HISTORICAL ADVISORY BOARD AGENDA REPORT

APPLICATION: **Certificate of Approval – PLN11-0272 – 1518 Park Street – Italo Calpestri.** The applicant requests a Certificate of Approval to reconfigure the storefront of a contributor in the Park Street Historic Commercial District and remove the recessed corner entry and square off the building with retractable window panels on both facades.

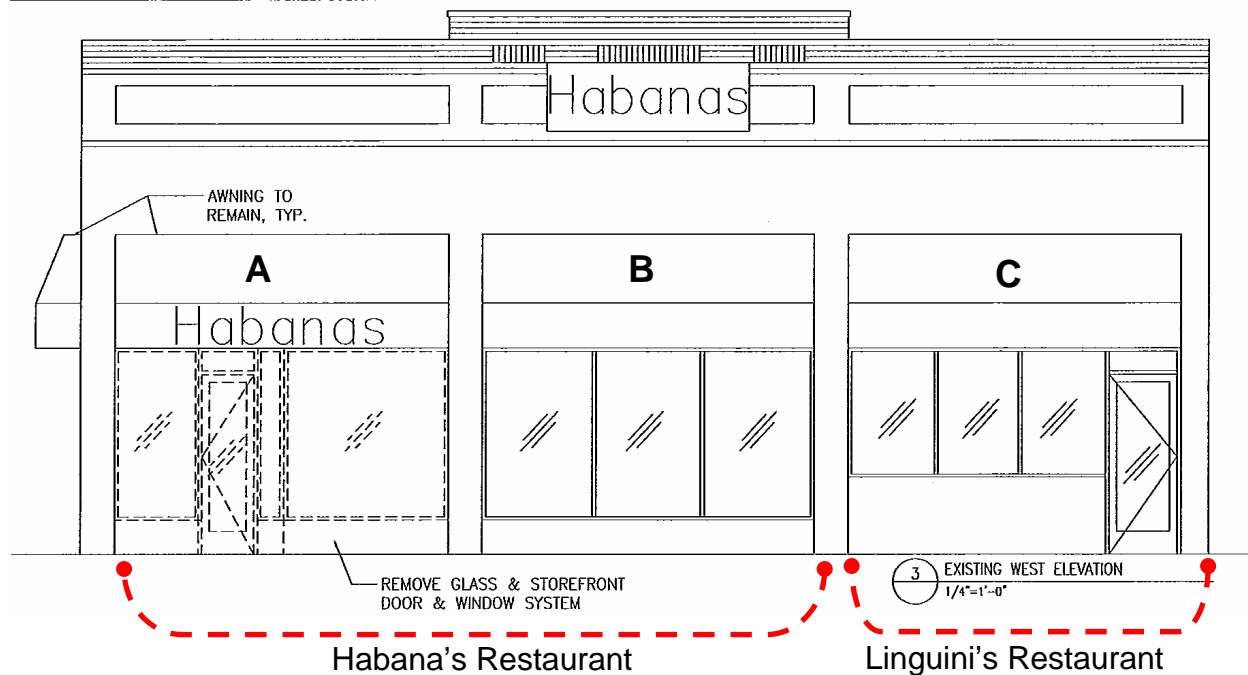
The building originally contained three separate spaces, with recessed entryways centered within the separate spaces. Spaces A & B were merged to contain the restaurant Habana's. Space C contains Linguini's, which is connected to the adjacent building. Based on City permit history, facades for spaces B and C were changed and have different window configurations. While the brick facades remain largely unaltered, over time the building received awnings and window reconfiguration for spaces B and C.

Habana's is requesting that the façade be altered for space A to allow outdoor dining, made possible through retractable window/door panes that open up the restaurant to the outdoors.

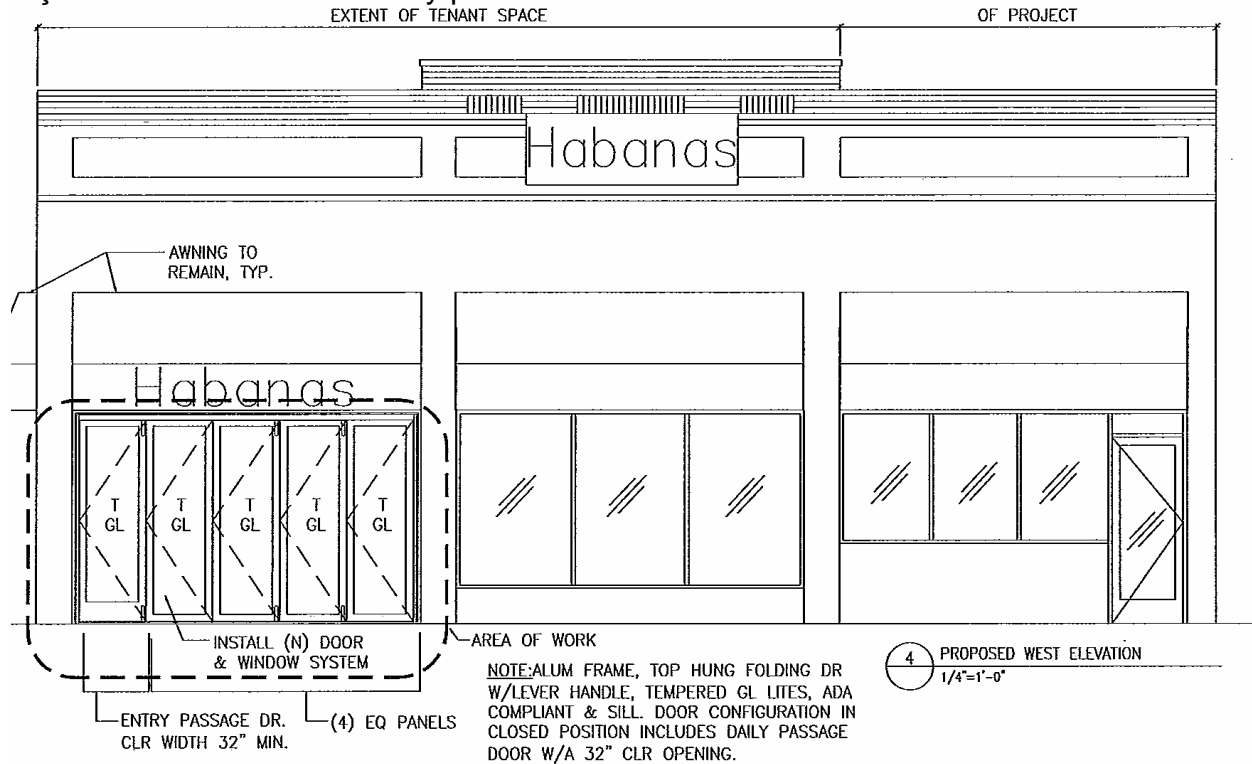
The proposed alteration of the windows and door configuration would square off the façade and create a new entry point for the restaurant.

The proposed retractable window and door panel configurations proposed for the northern and western elevation show a sufficient depth that would be suitable for a historic commercial structure. During summer months, when the panels are retracted, the open corner entry point would still be maintained.
